**Applicant's Post Hearing Submissions
(CAH, ISH 2 and ISH3)
TN 42 Station Drive Closure**

The West Midlands Rail Freight Interchange Order 201X

WEST MIDLANDS INTERCHANGE

Transport Technical Note 42 – Impact of Closing Station Drive at the Rail Bridge.

FIGURE 1

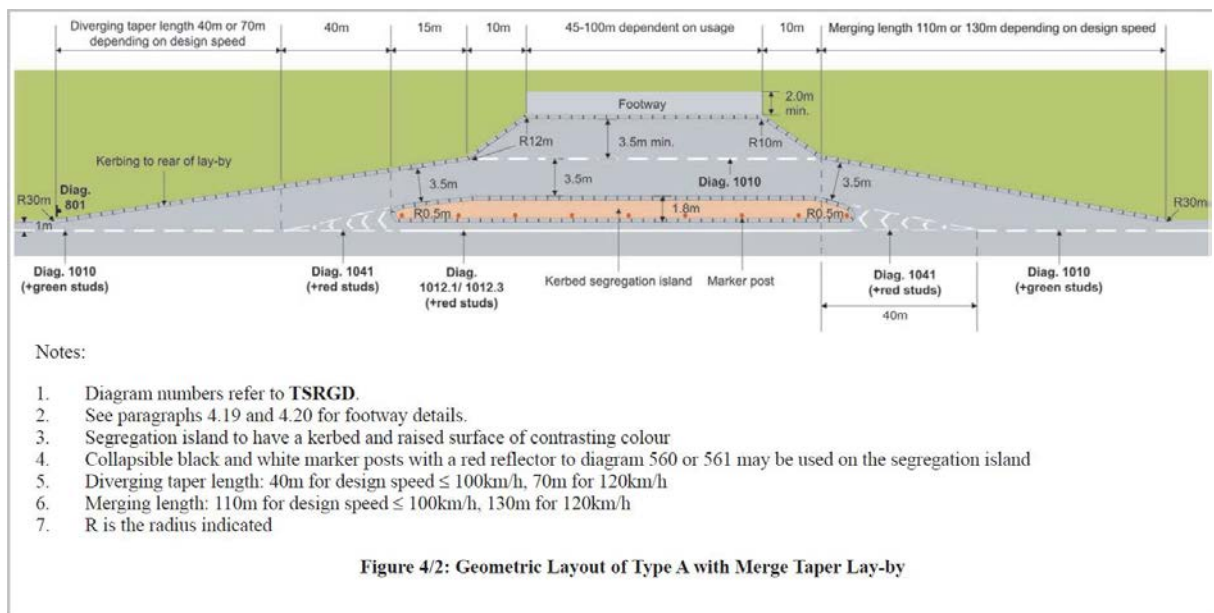
- 2.1 Due to the proposals for a new roundabout to be sited on the A5, the existing lay-bys are required to be relocated.
- 2.2 There are currently two existing lay-bys located on the A5 between M6 Junction 12 and Gailey Roundabout. The eastbound lay-by is located immediately east of the canal bridge, opposite the Gailey Marina Access. The westbound lay-by is located approximately 40m further east before the Harrisons Lane priority junction. Their locations are shown in red on Figure 1 below:

LAYBY USAGE CHARTS

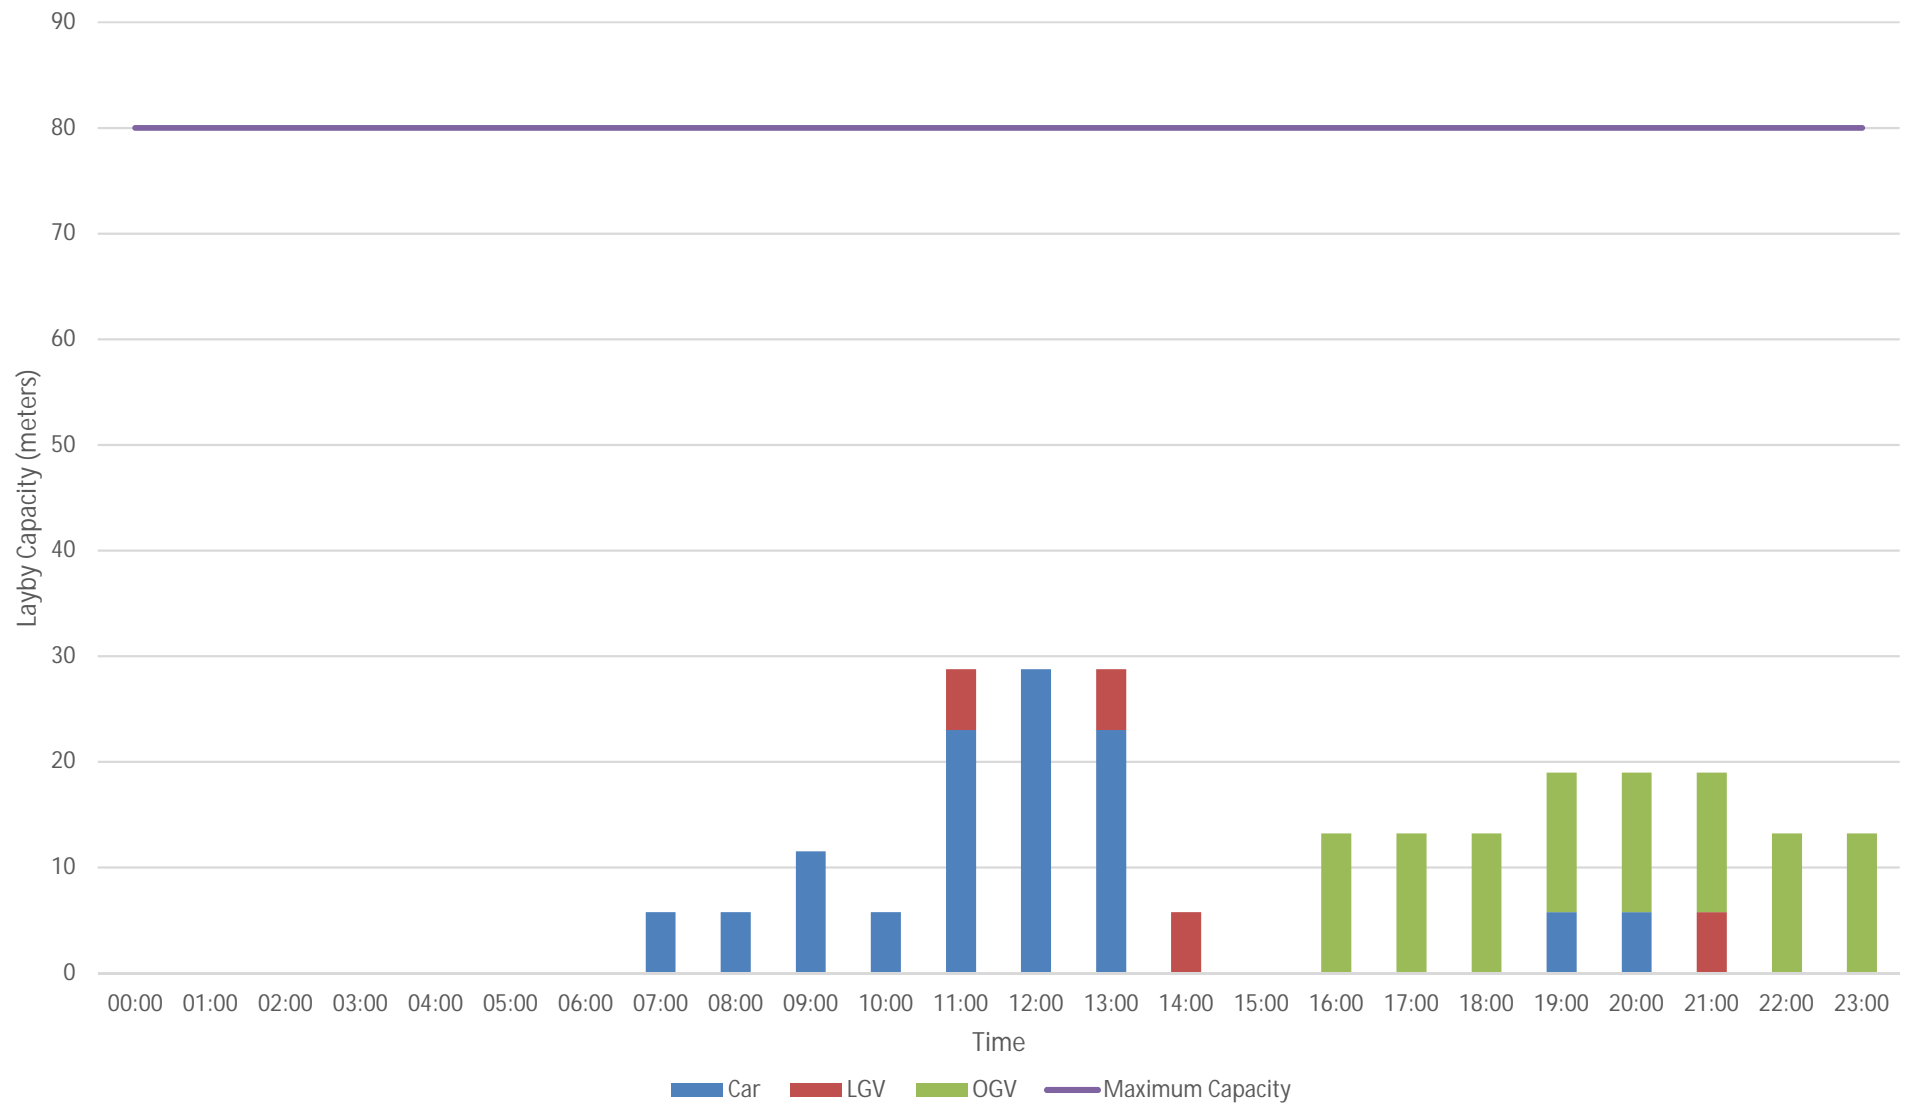
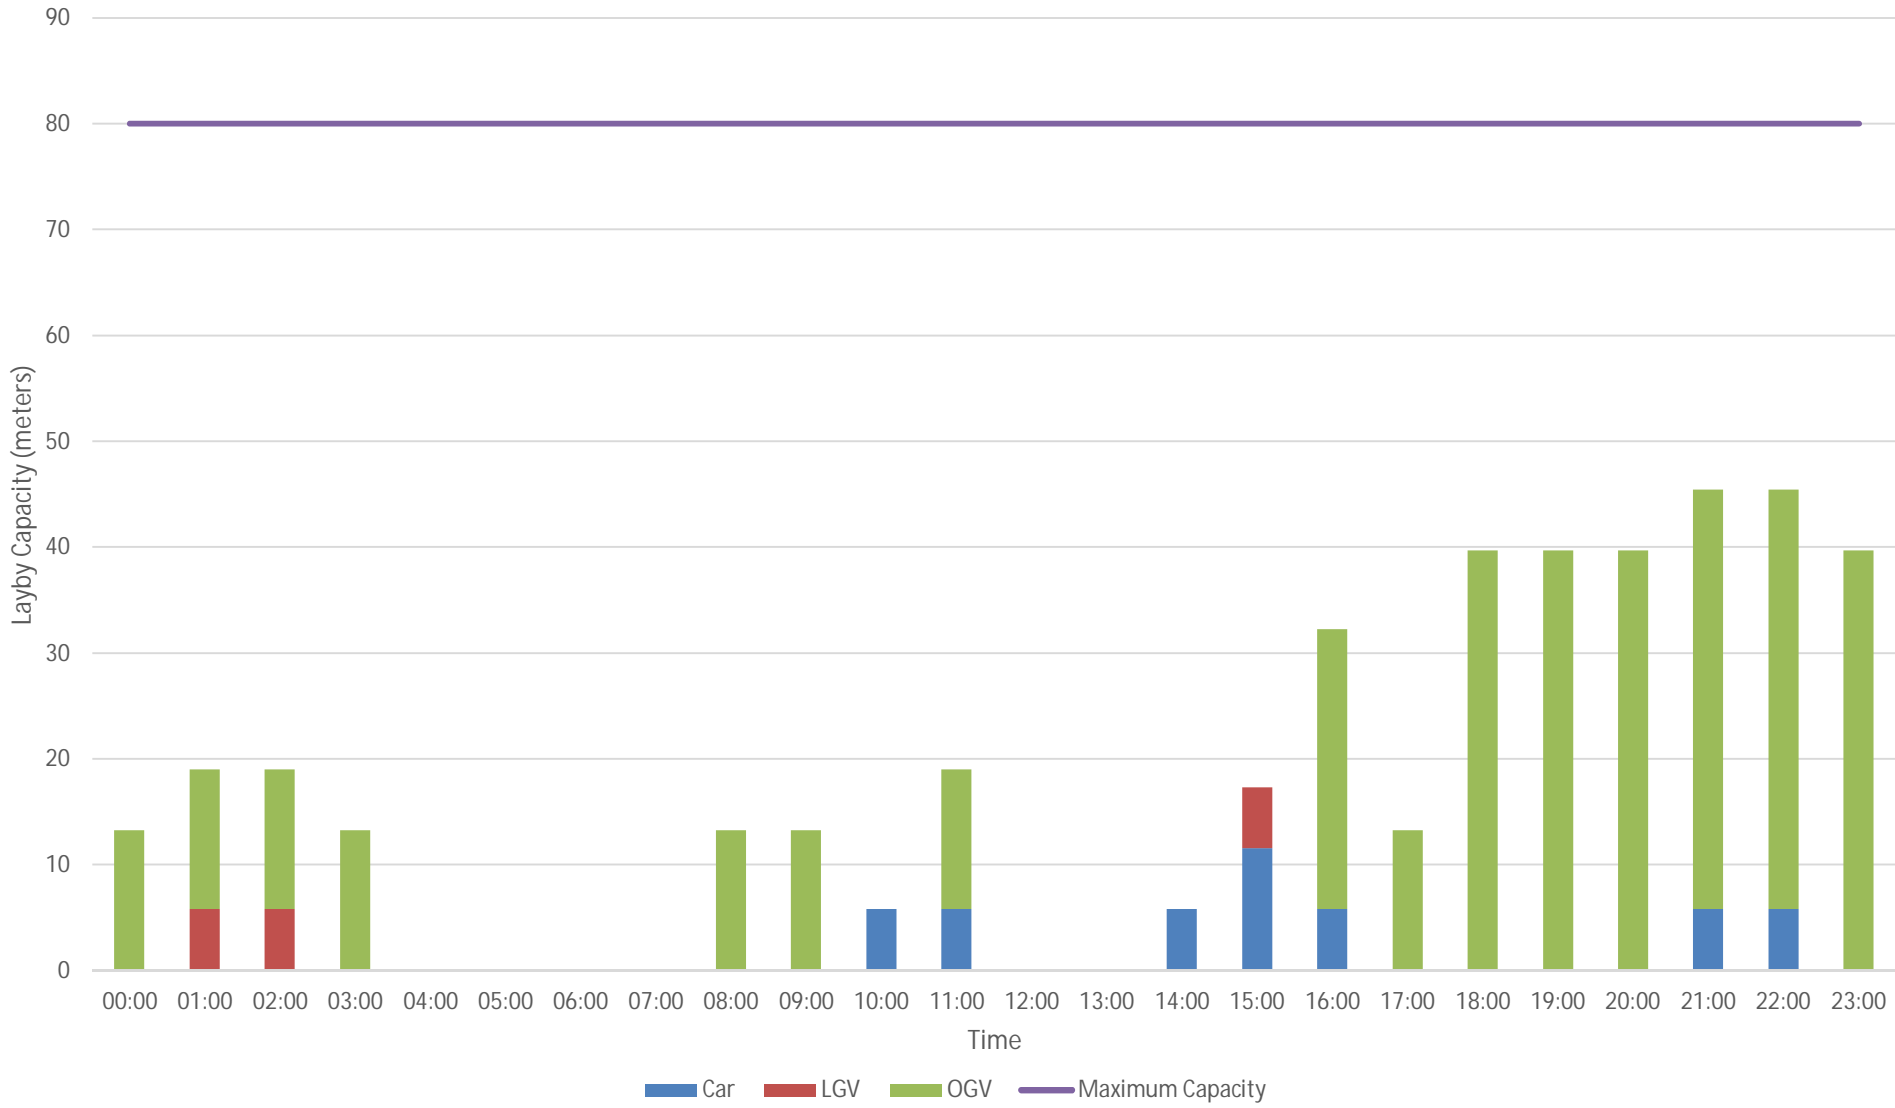
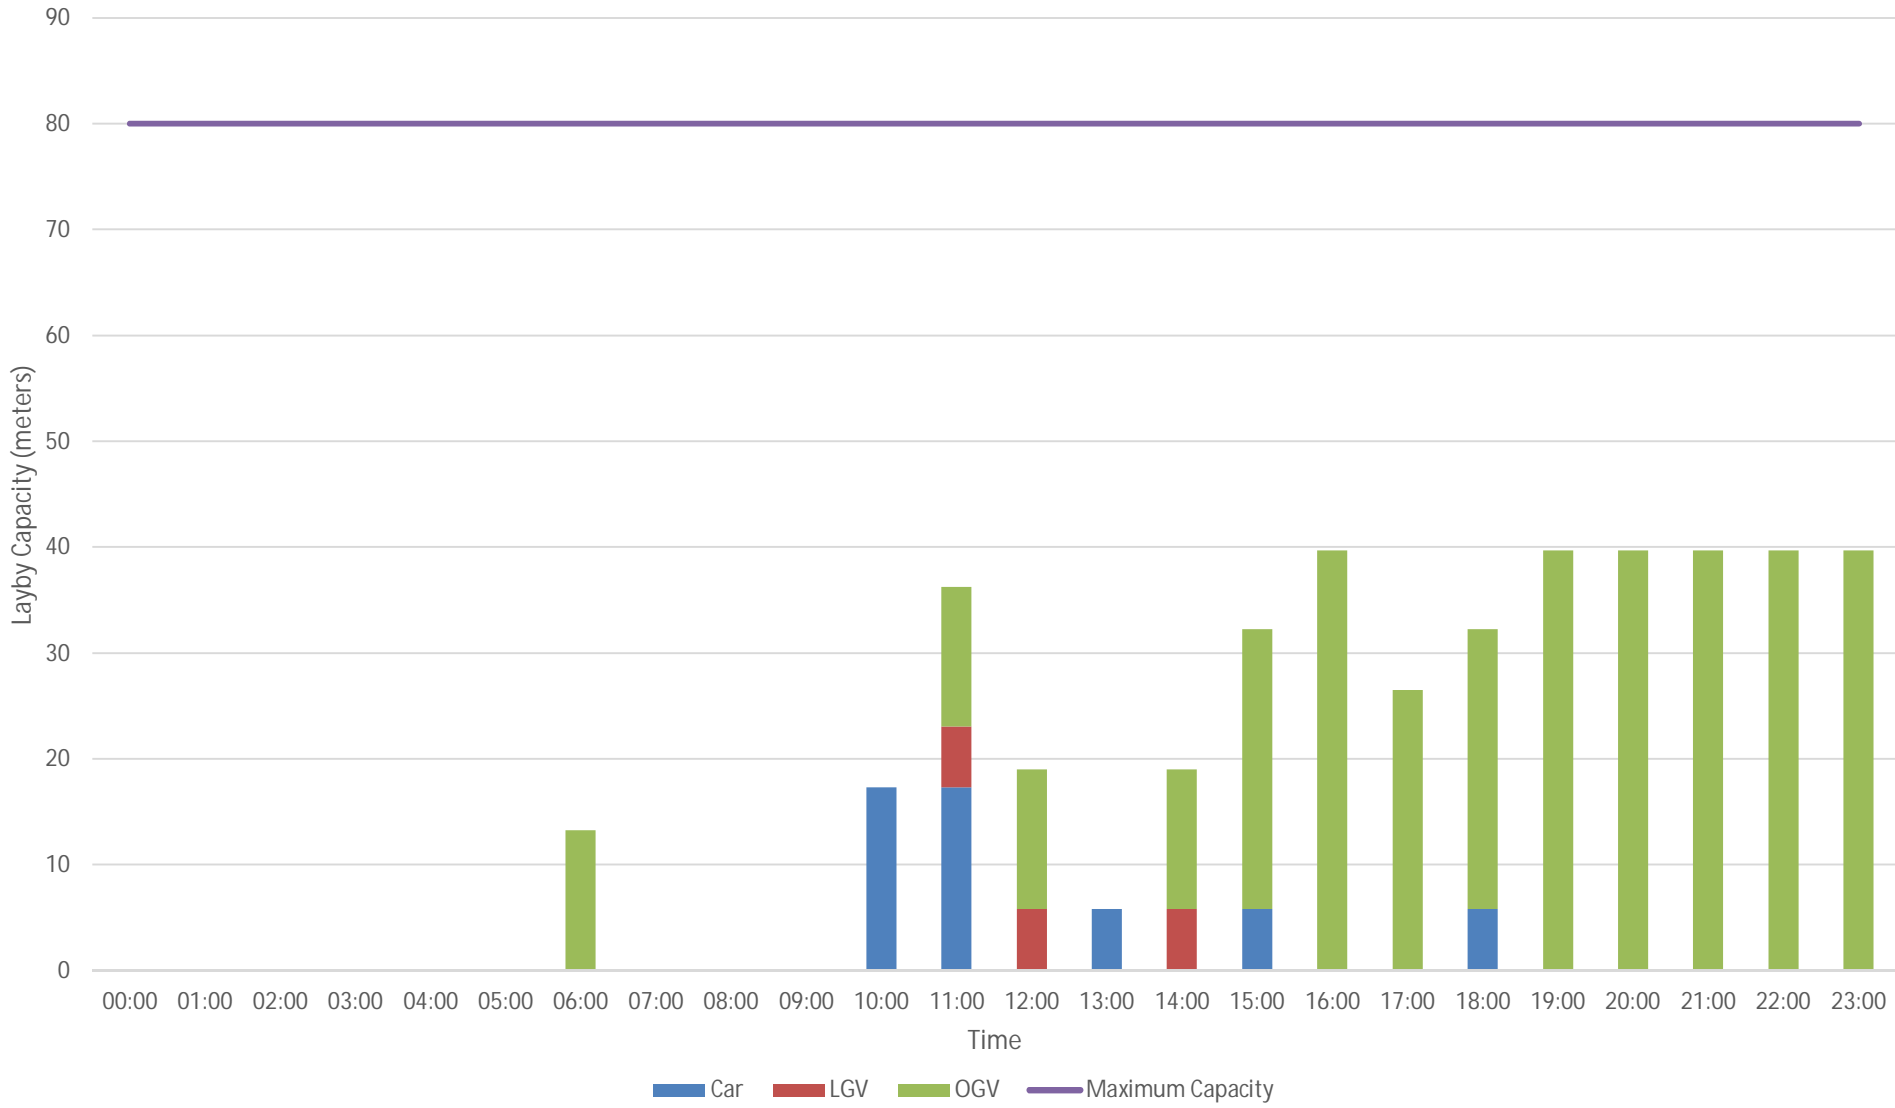
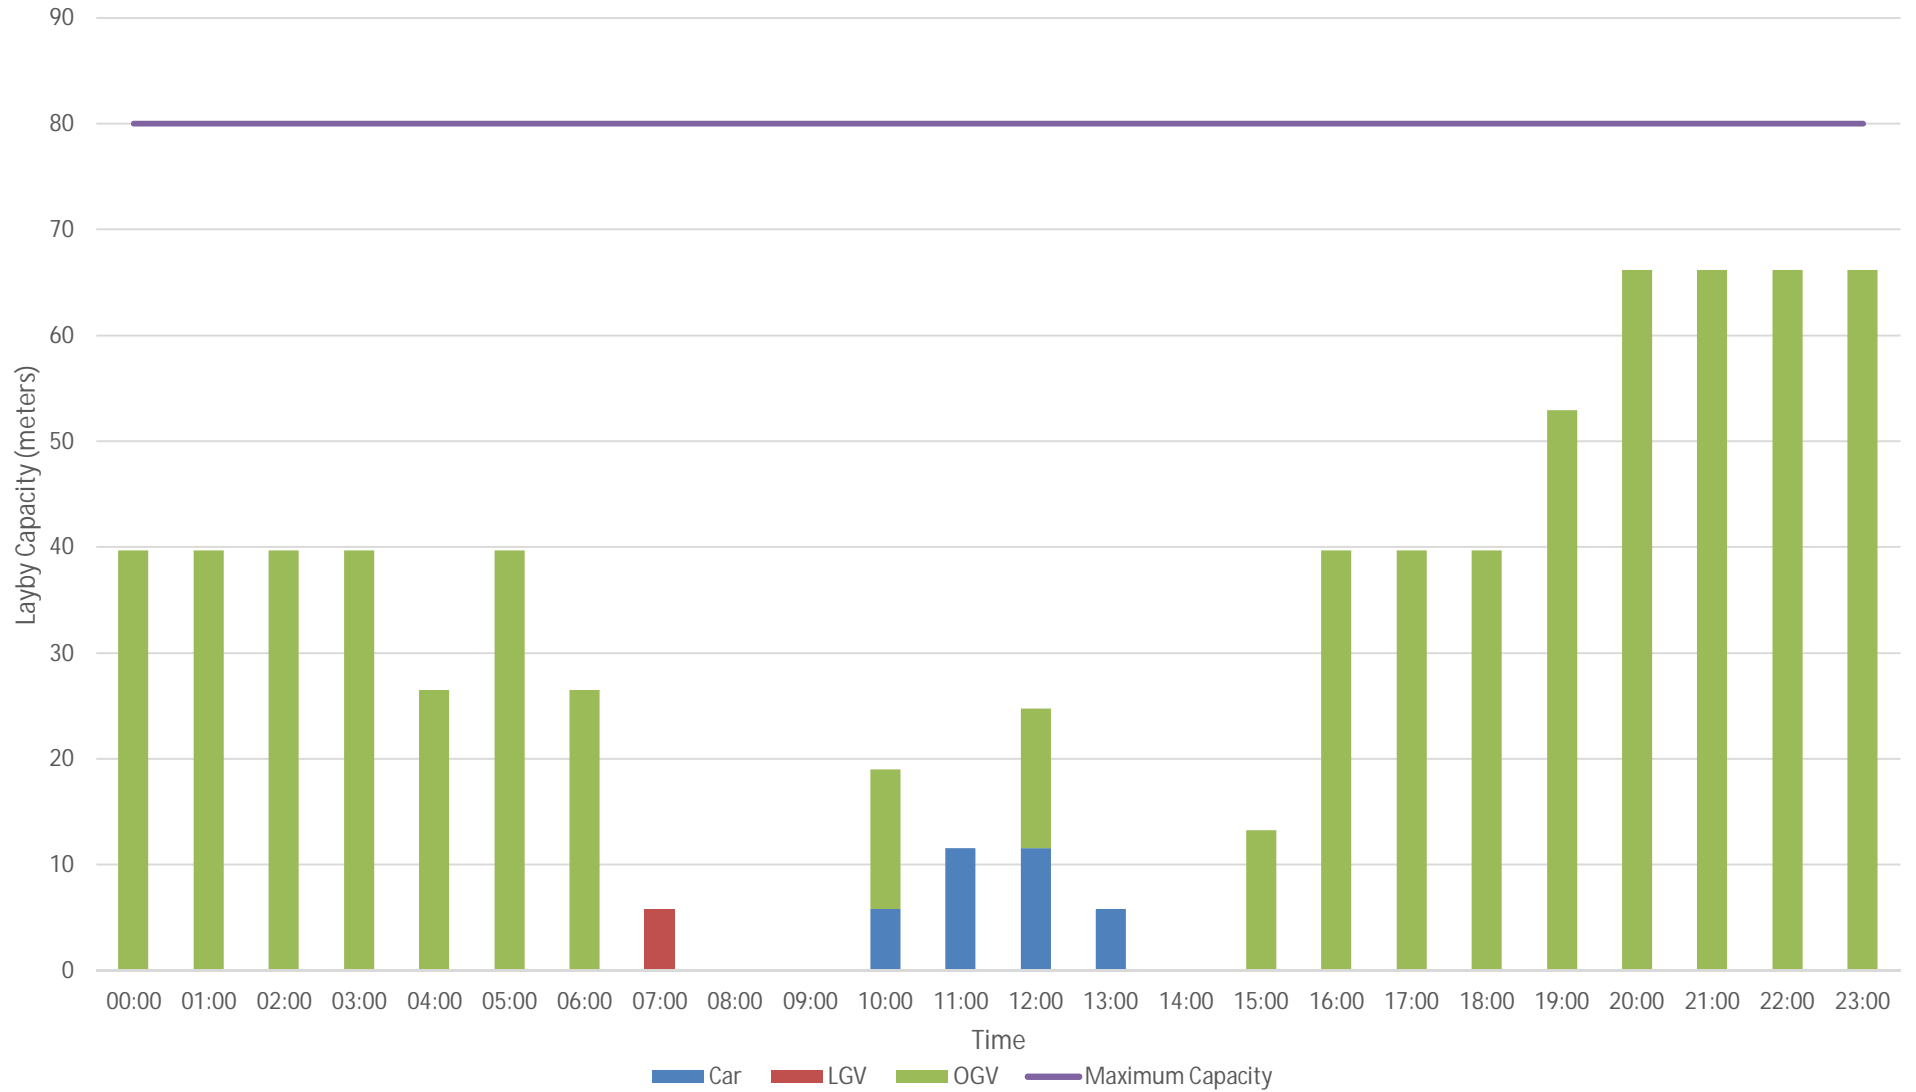
- 2.8 Comment has been made by Kier that the surveys of the existing laybys should have considered a greater duration extending to a period of seven days. In the context of this proposal, this is not considered necessary given that the proposal seeks to re-provide the existing layby length. It is not proposed to provide a reduction in length. Given that demand for the laybys can only amount to vehicles that can actually be physically accommodated, it is considered that it is not necessary to carry out demand surveys over a seven day period when the existing provision is being re provided.

- 3.11 As the lay-by capacity charts showed that neither lay-by reached full capacity, the new lay-bys will have the same storage length to accommodate parked vehicles. As specified above, the proposed lay-by's will however benefit from having a kerbed segregation island with the A449 and merge/diverge tapers which is in accordance with DMRB TD69/07. The provision of these elements will provide a safer design arrangement than is currently the case at the existing A5 lay-bys.
